### REMARKS

Fig. 1

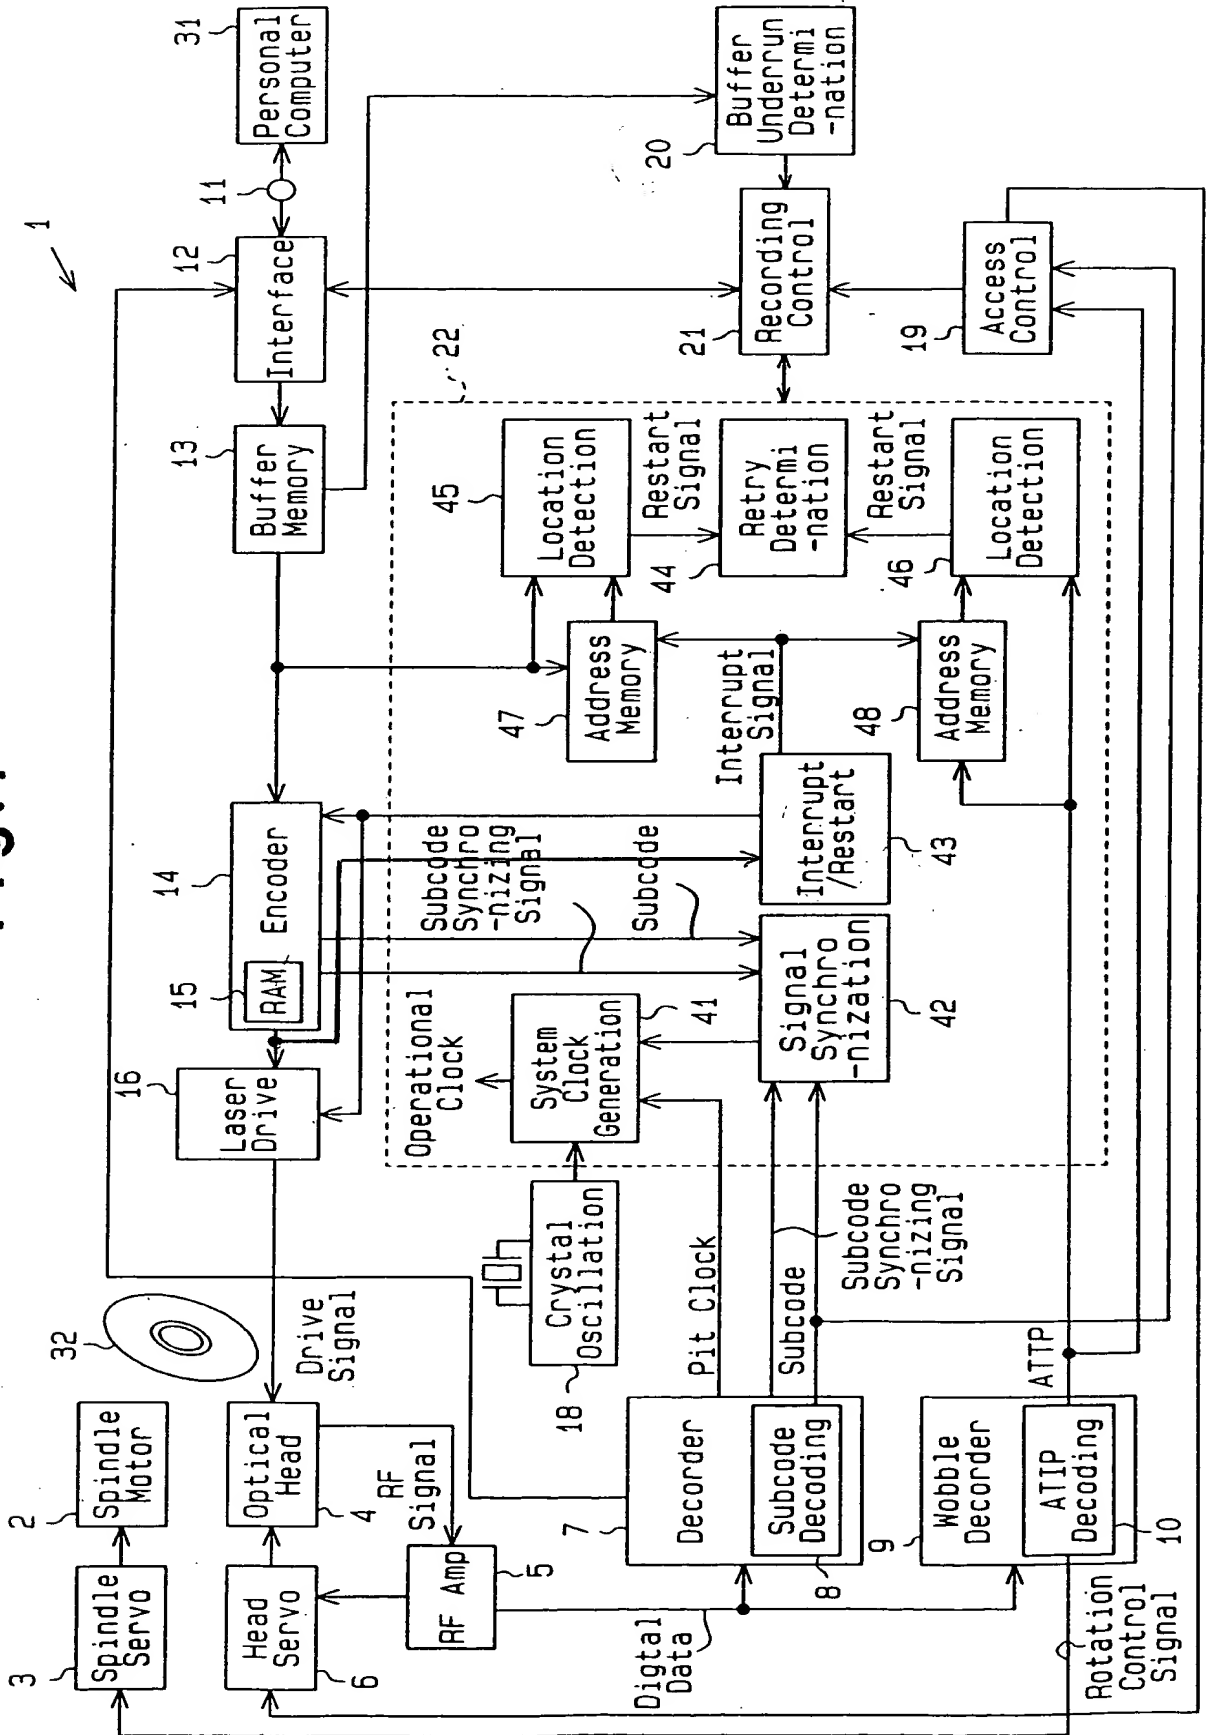
We have amended the title of the application and have amended Fig. 1 of the drawings to address the Examiner's objections to the Drawings. In particular, we have amended Fig. 1 to show a signal line that connects the interrupt/restart circuit 43 to a node between the encoder 14 and the laser drive circuit 16. The amendment of Fig. 1 is consistent with the specification (see page 15, lines 4-7). The signal line, appears in the original Japanese applications, JP 11-331419 and JP 2000-322550, from which this application claims priority. For the Examiner's convenience, Fig. 1 of the original Japanese application, JP11-331419, is attached to this letter, in which the signal line is highlighted. Please refer to the certified copies of the original Japanese applications, which were submitted to the USPTO on February 23, 2001.
